Re: Vancouver Fraser Port Authority Project Permit No. 15-041-3 - Amendment
Fraser Grain Terminal Ltd. – Fraser Grain Terminal - Grain Export Facility

RE: Permit No. 15-041-2: Proposed Permit Amendment 3

FRASER GRAIN TERMINAL

SOUTH DRAINAGE PLAN

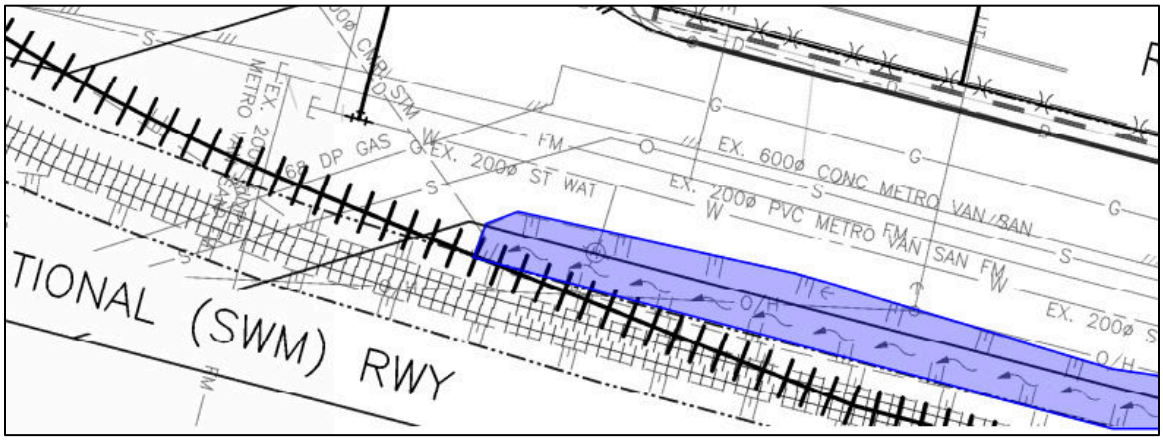
The proximity of the new FGT rail to the existing drainage ditch was not considered when submitting the original PER civil design package. After reviewing on site with the civil engineer of record it was determined that to prevent the new FGT rail bed from collapsing and sloughing in, a portion of the existing ditch would need be infilled and replaced with a new manhole and 300mm concrete class V storm line to reinforce the stability of the future rail line foundation. See attached ISL drawing 32022 C-07 R5 and below for original civil design.

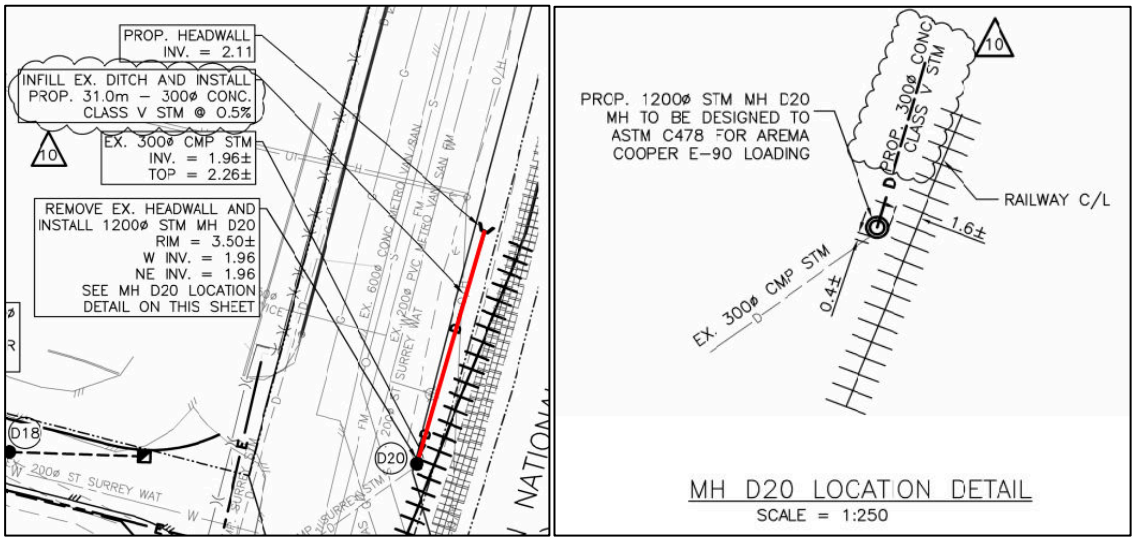
Minor modifications to the existing culverts by Robson Road are required to build and tie-in the new FGT rail track to the existing Canadian National (SWM) Railway. As it stands, the current layout would not be able to support the new rail loading and could result in the line sloughing into the ditch

Modifications include removing the existing headwall and installing a new 1200mm storm line D20 manhole design to ASTM C478 for AREMA Cooper E-90 loading and extending the existing 300mm corrugated metal pipe (CMP) storm line approximately 31m North. See below for the proposed storm line extension and new MH D20 location detail. See attached ISL drawing 32022 C-07 R10 for details
